Delegated Report		Analysis sheet		Expiry Date:		i) 27/11/2024 ii) 05/11/2024	
(Refusal)		N/A / attached		Consultation Expiry Date:		i) 03/11/2024 ii) 03/11/2024	
Officer				Application Number(s)			
Sam FitzPatrick				i) 2024/3836/P ii) 2024/4296/L			
Application Address				Drawing Numbers			
12 & 13 ('The Lodge') Primrose Hill Studios Fitzroy Road London NW1 8TR				Please refer to decision notice.			
PO 3/4		Area Team Signature		C&UD		Authorised Officer Signature	
Proposal(s)							
<ul style="list-style-type: none"> i) Erection of single storey extension to courtyard, with doors to both existing studio building and Kingstown Street. Alterations to southern and eastern boundary walls including increase in height and replacement of garage entrances with steel doors. ii) Erection of single storey extension to courtyard, with doors to both existing studio building and Kingstown Street. Alterations to southern and eastern boundary walls including increase in height and replacement of garage entrances with steel doors.

Recommendation(s):		<ul style="list-style-type: none"> i) Refuse planning permission ii) Refuse listed building consent 					
Application Type:		<ul style="list-style-ty

Figure 1: Proposed ground floor plan as approved under application ref. 2018/0191/P

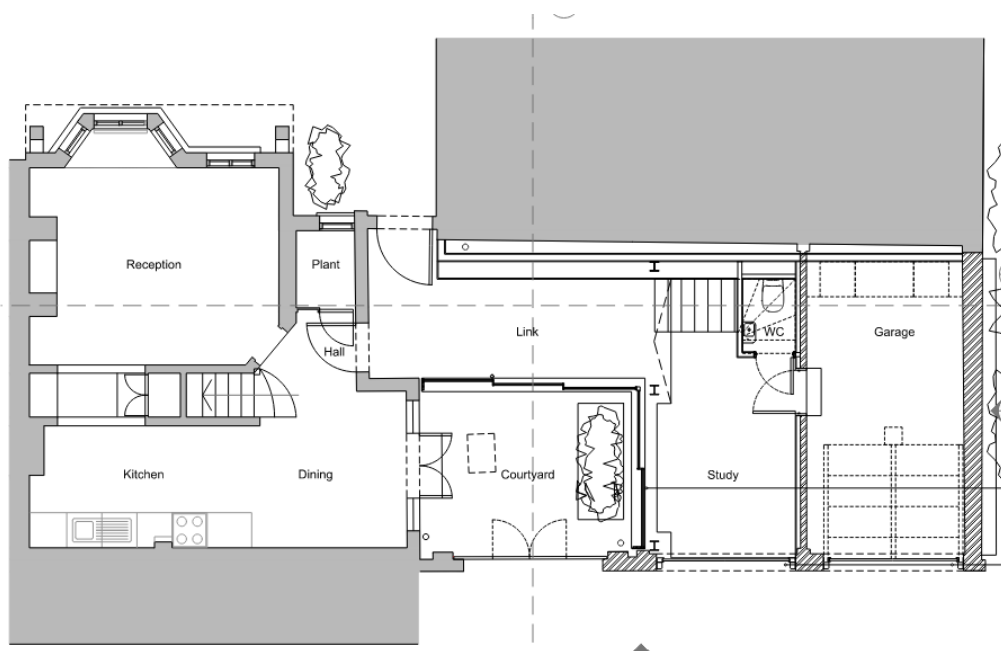
2.2. It is also important to note that there is permission previously granted at the site that has been implemented. This is detailed in this report's 'relevant history' section and involves erecting a first-floor extension over one of the existing garages and a single-storey link to The Lodge at ground level. This permission relates to The Lodge only, as set out by the red line boundary, the approved drawings, and the decision notice. The approved extension at ground level would provide a route into The Lodge and the shared central yard only, and there is no link to the studio building at no.12. For clarity, the approved ground floor plan is provided below in Figure 1.

Figure 2: Proposed ground floor as applied for under this application (ref. 2024/3836/P).

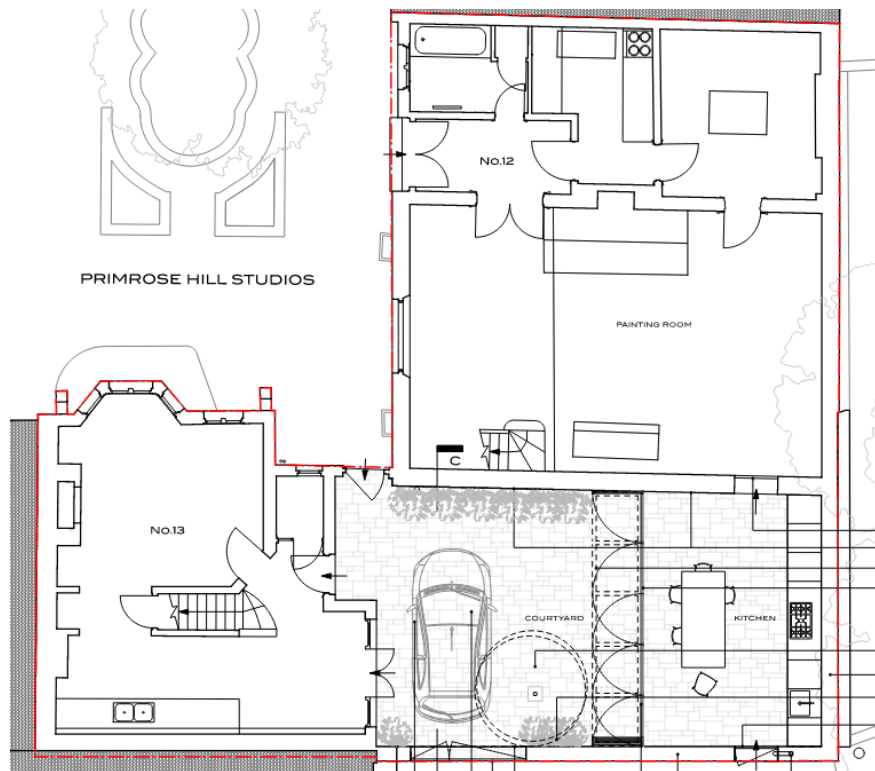
4.5. The proposal involves the erection of a single storey extension to no.12, which is one of the artist's studios. However, the extension would be built within the courtyard of The Lodge, where garages previously existed but have since been demolished, due to the implementation of the previous permission as set out in the 'relevant history' and 'background' sections of this report. The extension would be accessed from the existing studio/painting room of no.12 through a new opening to the southern elevation, and would host a kitchen with glazed doors that open west into the courtyard. This layout is shown in figure 2, which provides the proposed ground floor layout of the application.

gardens, in part due to their smaller footprints. The yard within which the proposed extension would be located historically appears to have belonged to The Lodge. However, regardless of ownership, the positioning of the new extension and its access into the courtyard would fundamentally alter the relationship between the two properties; by erecting an extension to no.12 that opens onto The Lodge, the existing layout of two separate and unrelated dwellings would be replaced with an intimate face-to-face layout, which would change the houses' relationship to each other.

- 4.8. The proposed extension to no.12 and its large, glazed doors opening onto the yard of The Lodge would fundamentally blur the distinction between the two properties, altering the historic relationship. Previous schemes, whilst differing in size and layout, did not provide access from the artist studio into the yard, but kept the two dwellings distinct and separate. This proposal fails to achieve the same result.

- 4.9. In addition to the harmful impact on the historic relationship between the two properties, the addition of the rear extension to the artist's studio interferes with what should be a simple and large internal volume, whilst damaging and removing historic fabric through the creation of an opening. As such, the route through from the large open space that constitutes much of the internal area of no.12 into the new kitchen room would be harmful to plan form.

4.14. The proposed extension at ground level would, by reason of its scale, position, and siting, undermine the historic relationship between the two listed buildings, disrupt the planform of the host property, and result in the loss of historic fabric, resulting in harm to the special interest of the host buildings themselves and the character and appearance of the Primrose Hill Conservation Area. Therefore, the proposal fails to comply with Policies D1 and D2 of the London Borough of Camden Local Plan, which constitutes a reason for refusal.

5.3. The rear extension does include large, glazed doors that open west into the courtyard of The Lodge. These would directly face the east elevation of The Lodge, with a distance of approximately 5.5m from the doors to the nearest part of the neighbouring building.

privacy between existing properties facing proposed development. Although there is some flexibility with regards to separation distance, the extremely short distance and extent of glazing to the proposed extension would result in direct overlooking between the two properties. Irrespective of the current ownership of the properties, this would result in a harmful impact to the amenity of future occupiers of the two units, and so would fail to comply with the Council's policies and guidance on amenity impact.
